# Access Compliance Report

## Public Rights-of-Way

Intersection ID: 18238	Main Street: QUEEN ANNE RD	Cross Street: S TRYON ST	Location: NE
ADA ID: 4321305DF603	Ramp Type: Directional	Initial Pass/Fail: Pass	Overall Compliance: No
Codes/Mitigation Info/Possible Solution			Severity Score: 0
			Field Measurements/Component Compliance

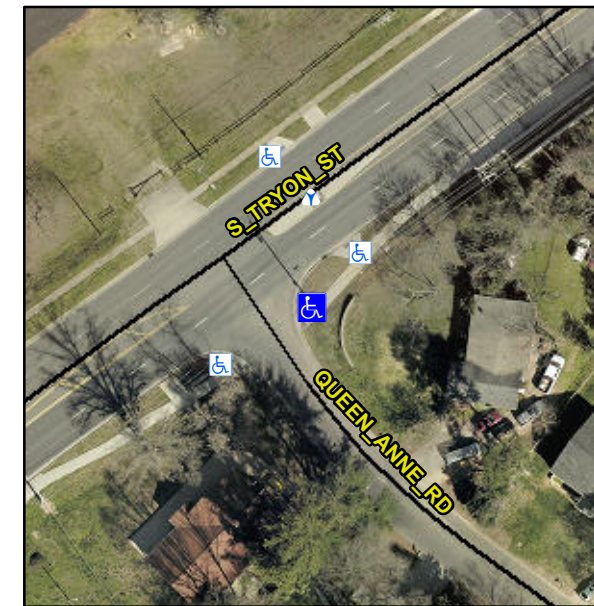
**R304.5.2**

**Remove & Replace Entire Ramp.**
